**UNIVERSITY OF CALIFORNIA, RIVERSIDE
STUDENT SUCCESS CENTER
PROJECT NO. 950512**

**Final Initial Study/Mitigated Negative Declaration
State Clearinghouse No. 2019089058**

SECTION 2.0 PUBLIC COMMENT LETTERS AND UNIVERSITY RESPONSES

Figure 11

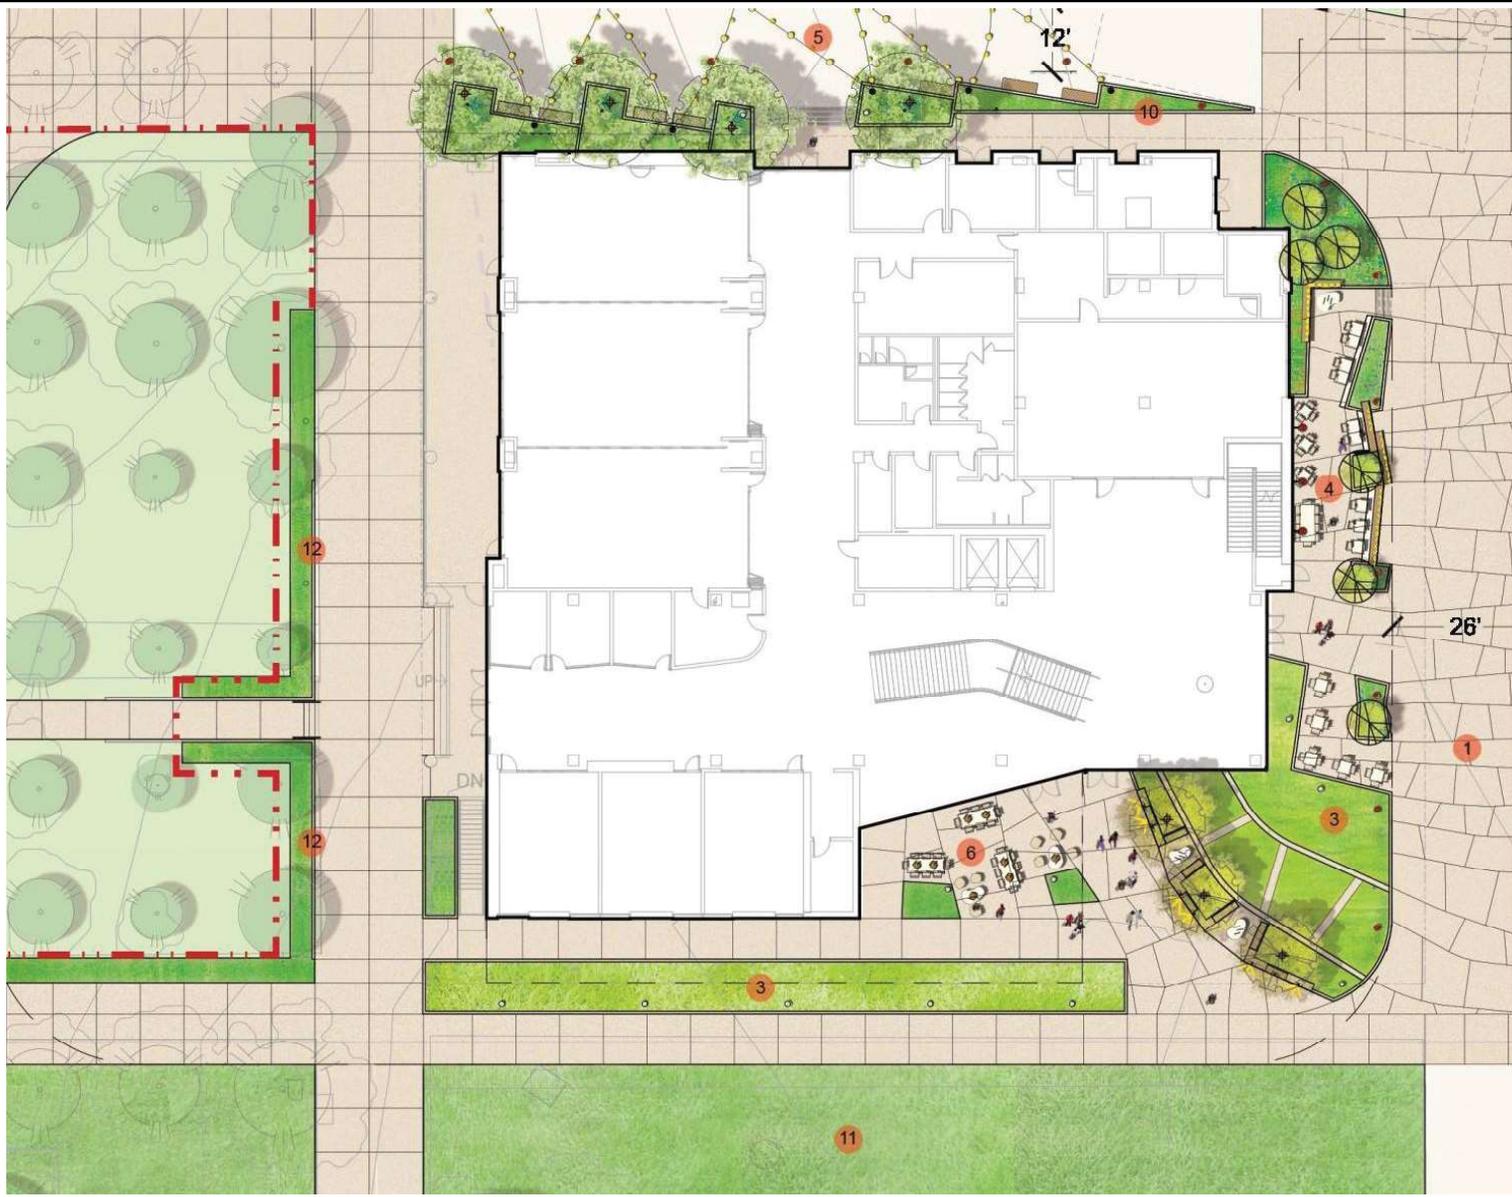
The project site is located adjacent to two major campus pedestrian/greenway corridors: the Carillon Mall to the south and the Arts Mall to the west. The proximity to these open space areas provide landscape, trees, and mature trees. Additionally, the proposed project would involve planting new trees within the project site (refer to Figure 11, Conceptual Landscape Plan of the Draft MND).

Figure 12

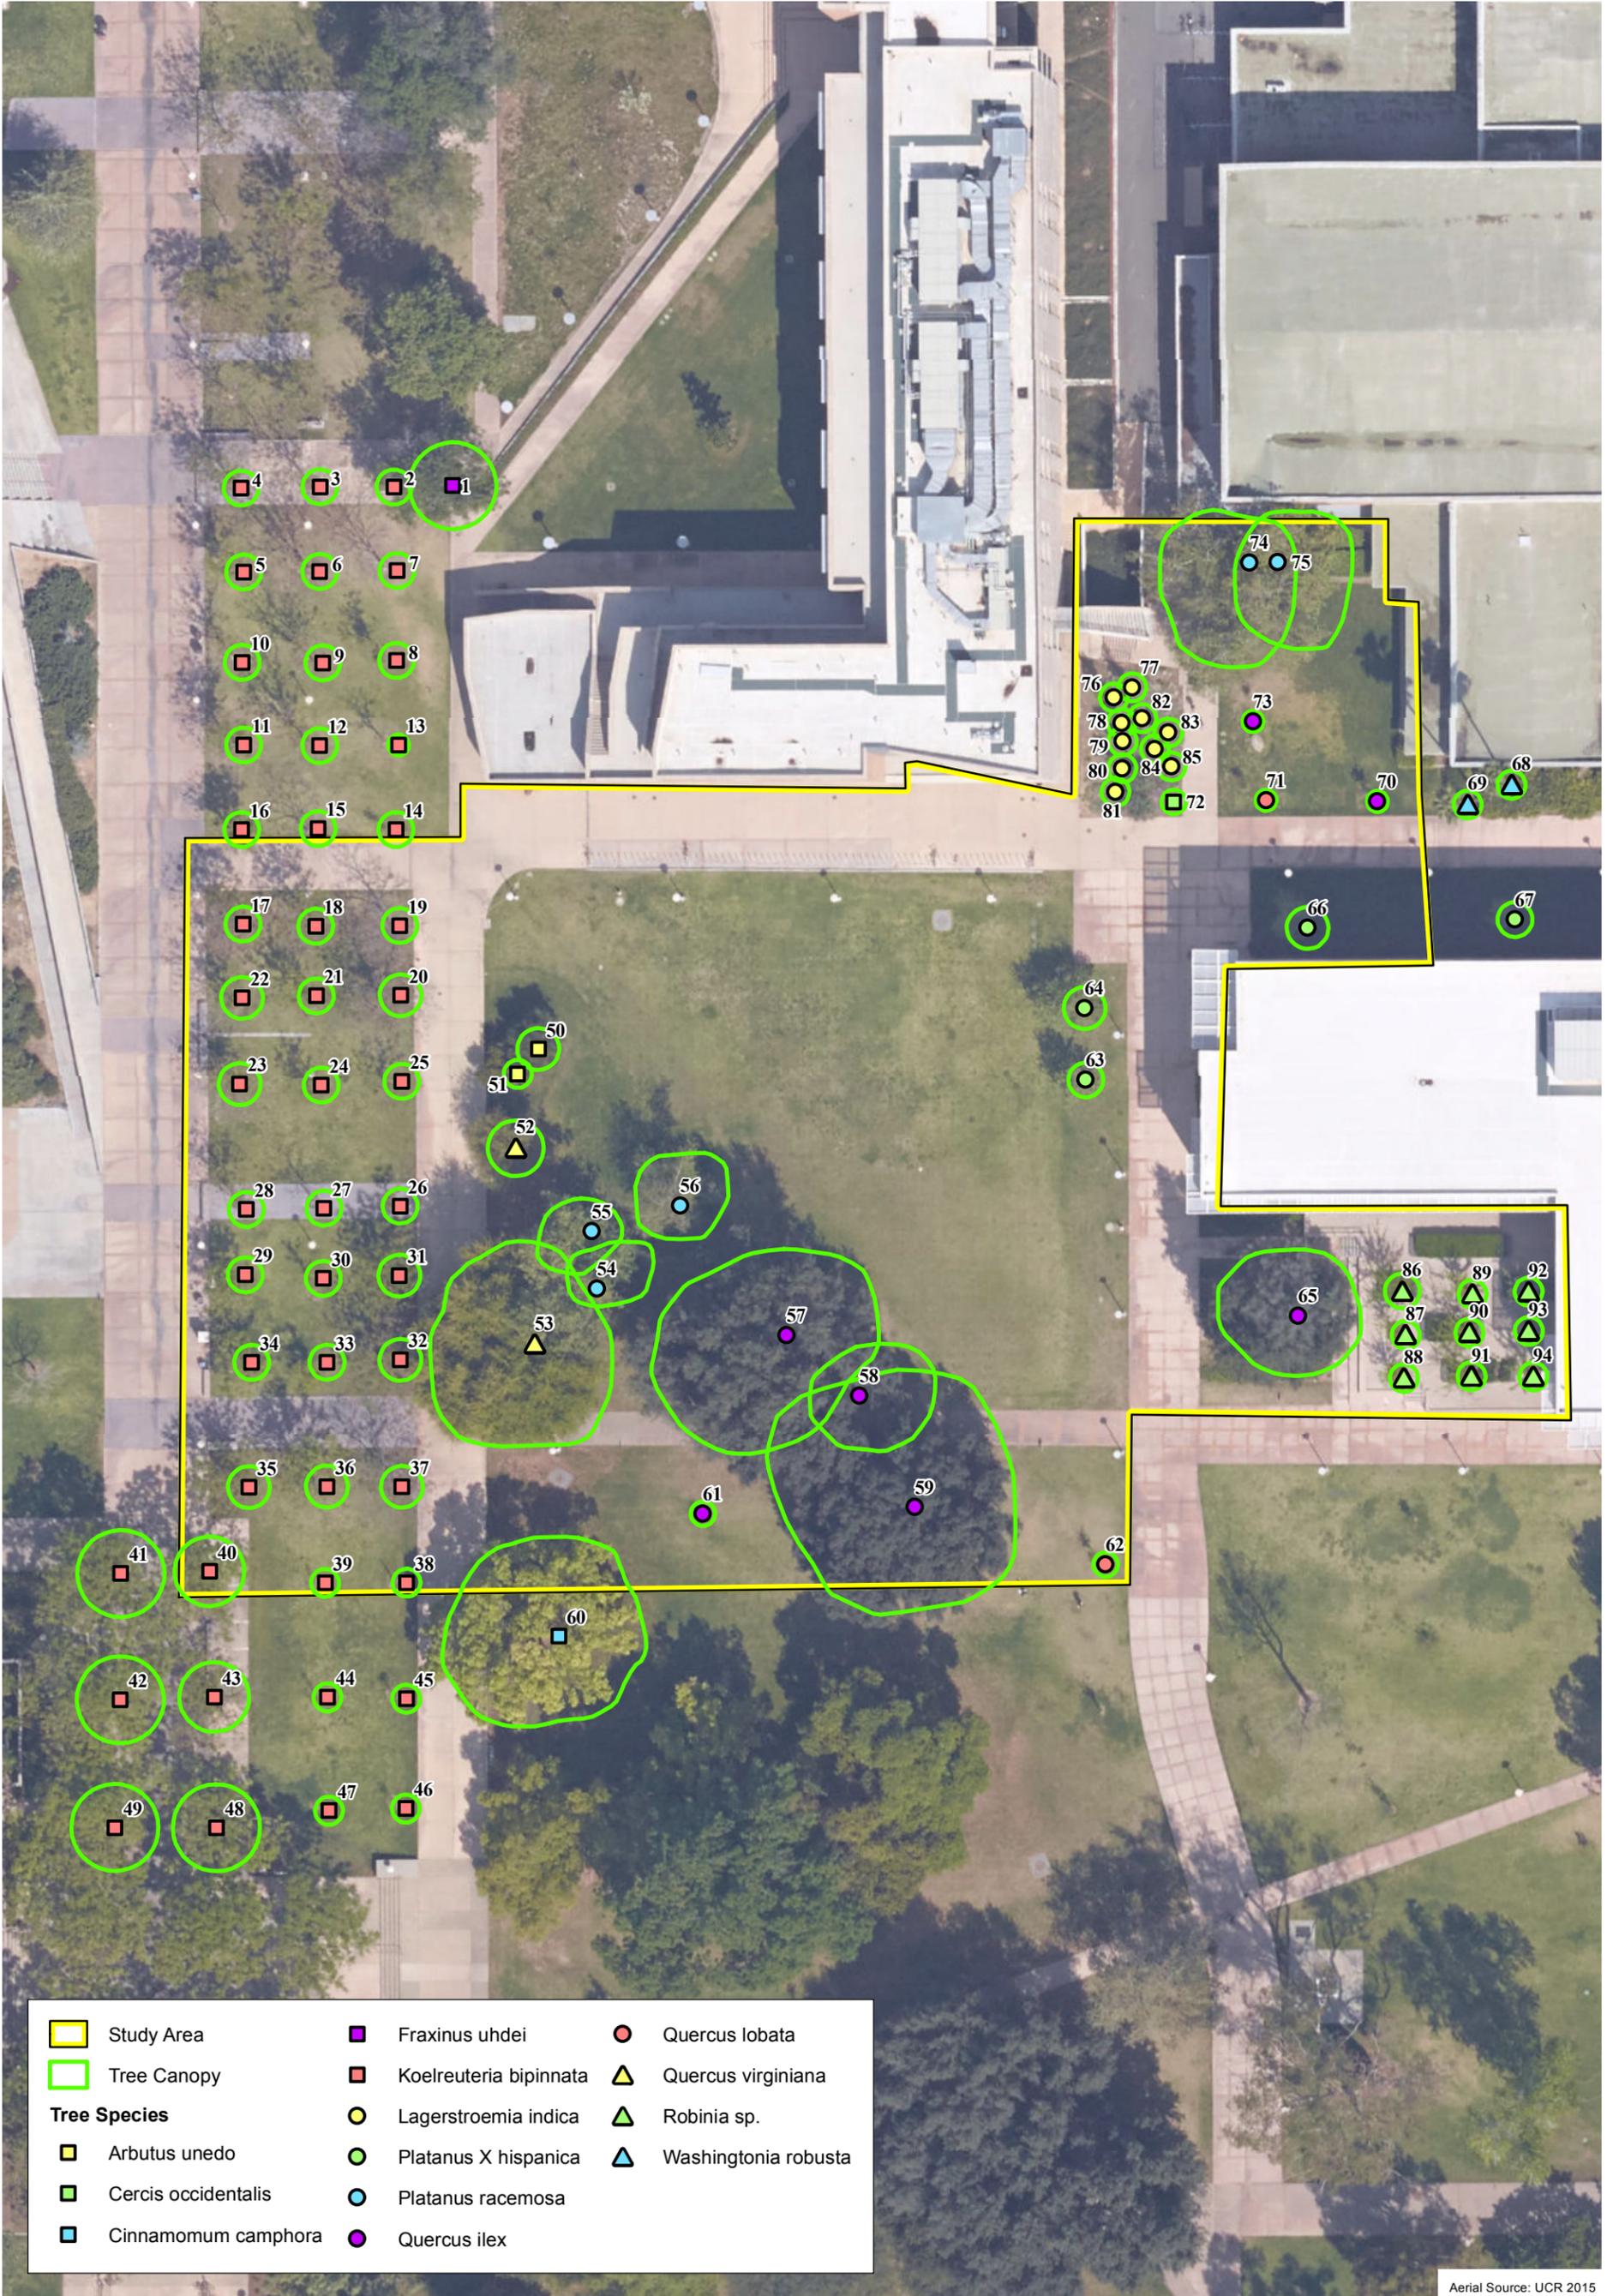
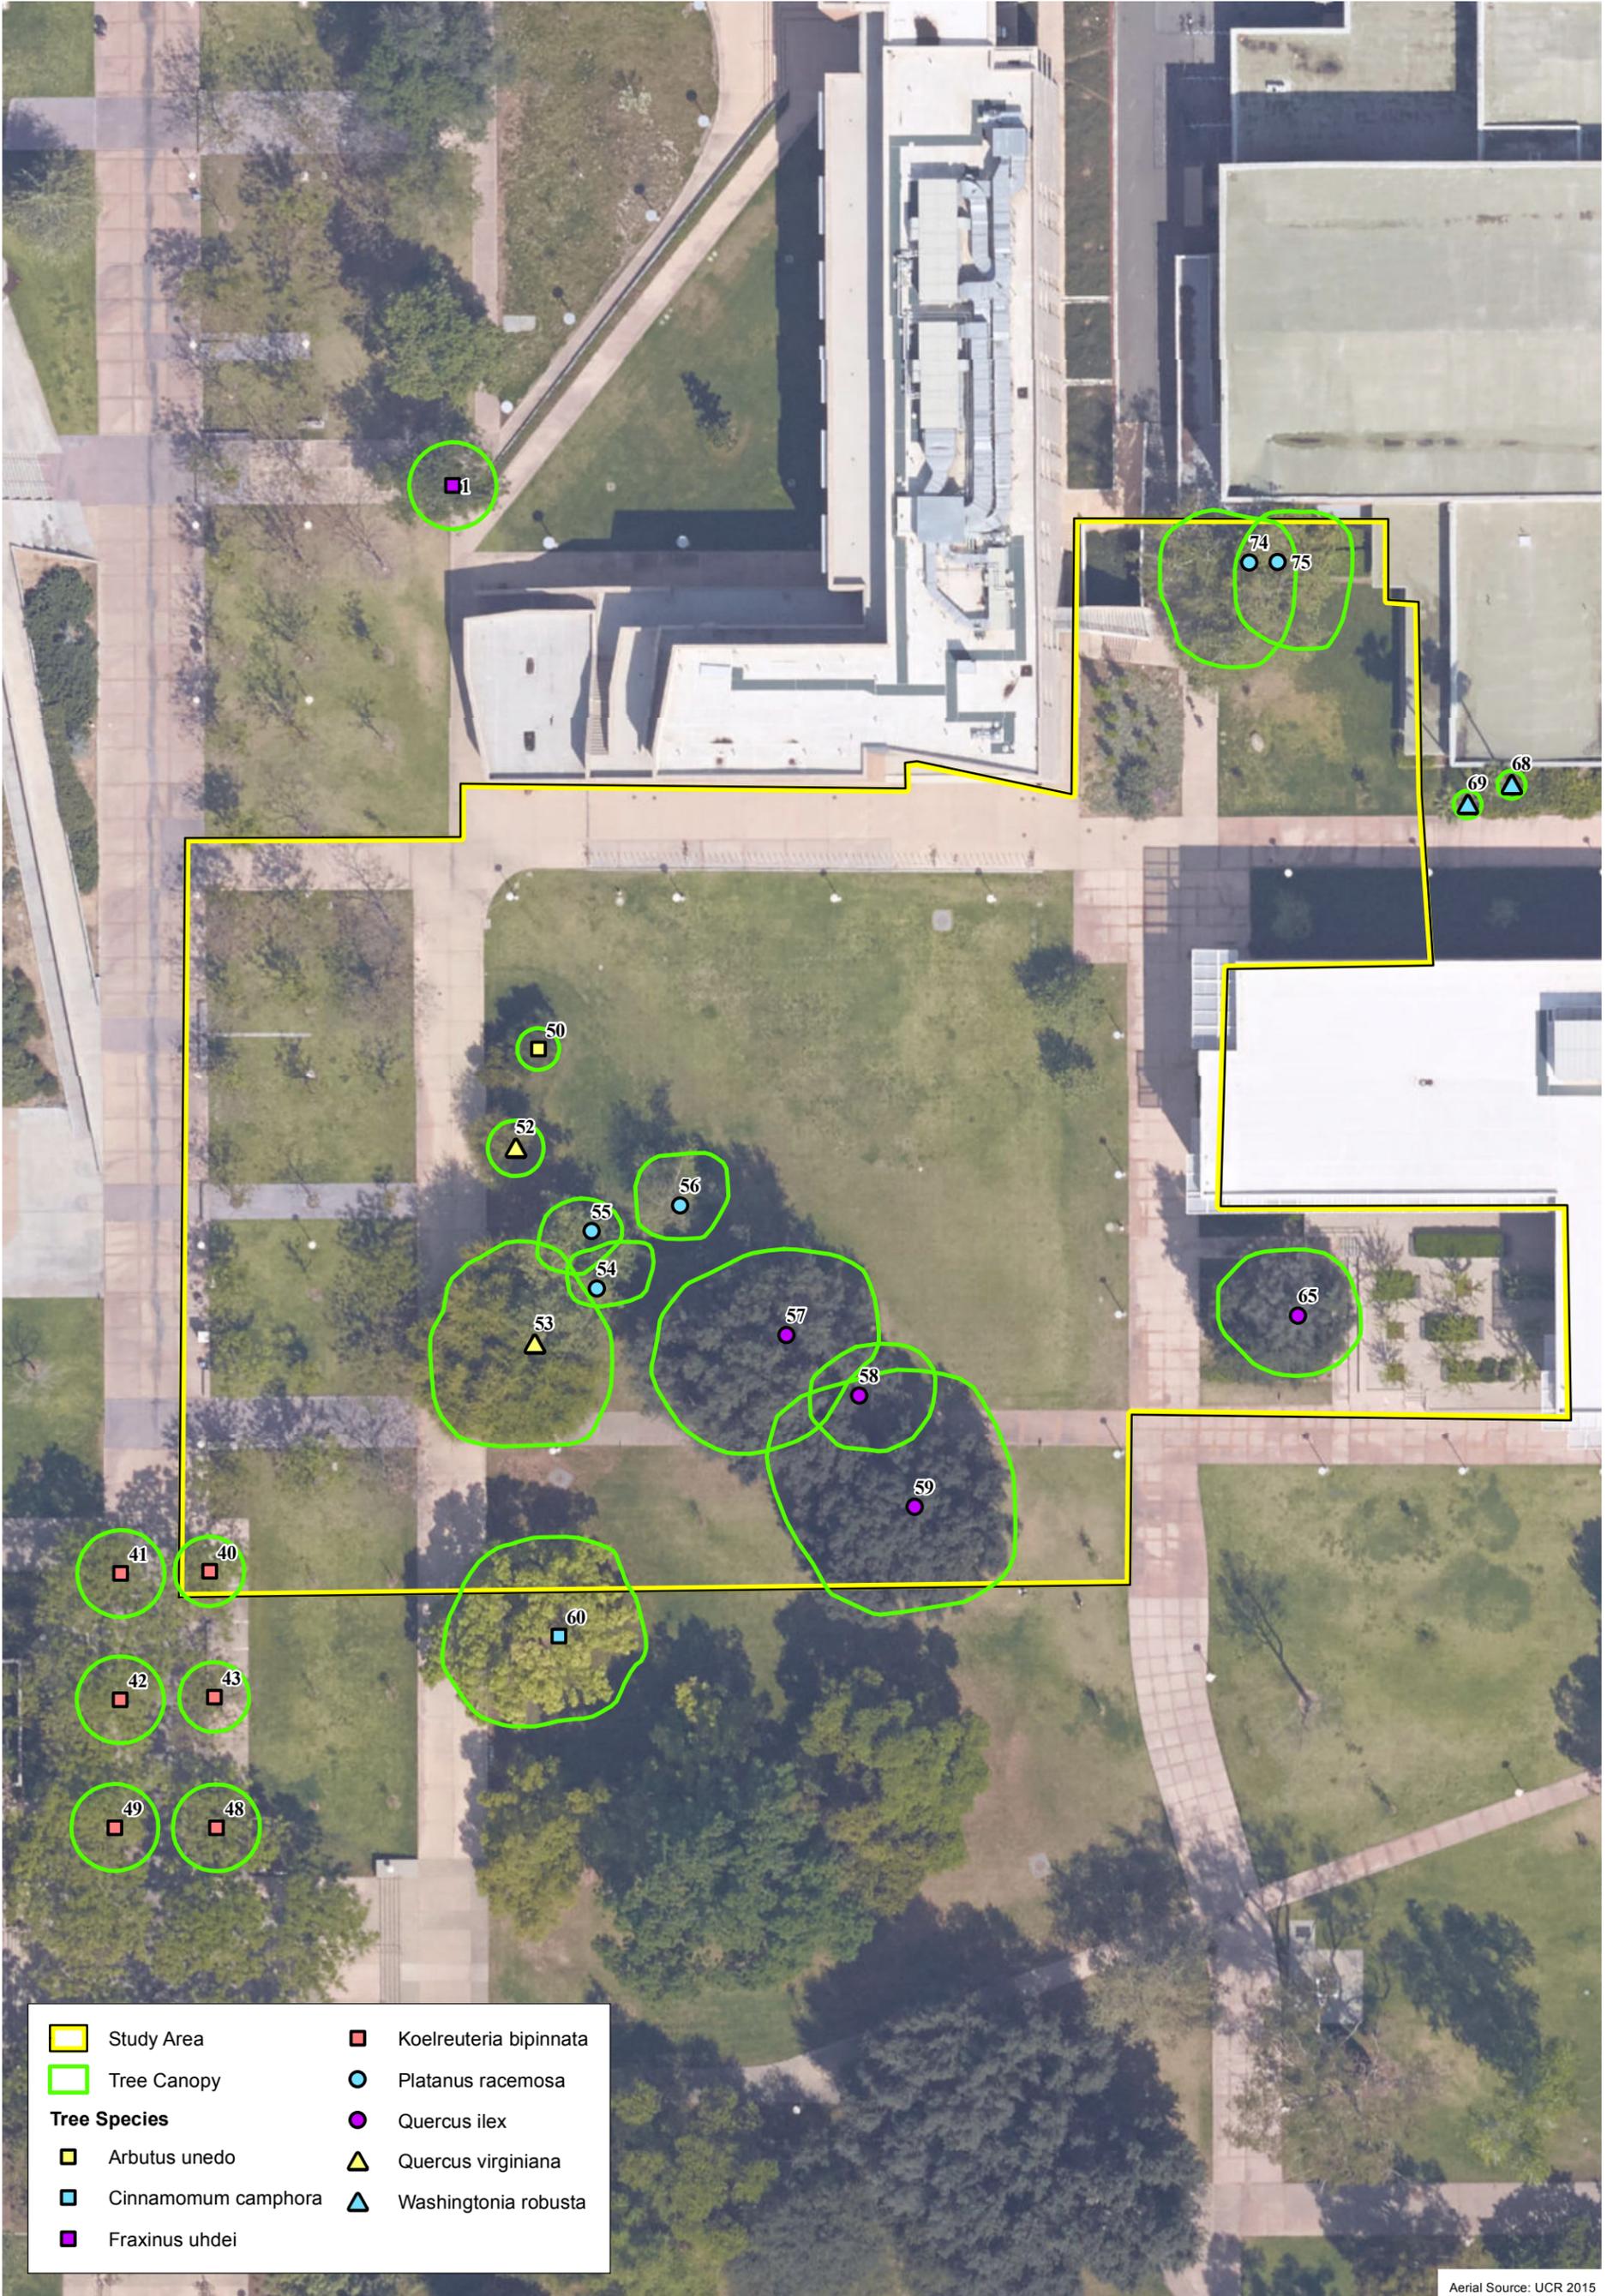
Figure 12, Tree Locations, identifies 22 mature trees (trees with a tree trunk diameter at breast height [dbh] of 12 inches or greater) that were surveyed in and around the project site. As shown, mature trees that occur in the project study area include one strawberry tree (*Arbutus unedo*), five western sycamores (*Platanus racemosa*), four holly oaks (*Quercus ilex*), and two southern live oaks (*Quercus virginiana*). A summary of relevant information for each tree is provided in Appendix B (e.g., type, height, dbh, canopy diameter, health, and aesthetics). Generally, transplantation of the trees in the study area is not recommended due to the size and age of the tree relocation with a likelihood of eventual mortality. Project implementation would require removal of on-site vegetation, including 34 trees, ~~of which 11 will be replaced in proximity to the project site. An additional 18 existing trees will be either protected in place or removed and replaced in place. As previously discussed, the project shall provide a 3:1 replacement ratio for mature “specimen” trees removed as part of the project with a diameter at breast height of at least 12 inches (four oak trees apply – refer to tree # 53, 57, 58, 59 on Figure 12). The project shall also provide a 1:1 replacement ratio for the remaining trees proposed for removal (approximately 30 trees).~~

Figure 12, Tree Locations, identifies 22 mature trees (trees with a tree trunk diameter at breast height [dbh] of 12 inches or greater) that were surveyed in and around the project site. As shown, mature trees that occur in the project study area include one strawberry tree (*Arbutus unedo*), five western sycamores (*Platanus racemosa*), four holly oaks (*Quercus illex*), and two southern live oaks (*Quercus virginiana*). A summary of relevant information for each tree is provided in Appendix B (e.g., type, height, dbh, canopy diameter, health, and aesthetics). Generally, transplantation of the trees in the study area is not recommended due to the size and age of the tree relocation with a likelihood of eventual mortality. Project implementation would require removal of on-site vegetation, including 34 trees, of which 11 will be replaced in proximity to the project site. An additional 18 existing trees will be either protected in place or removed and replaced in place.
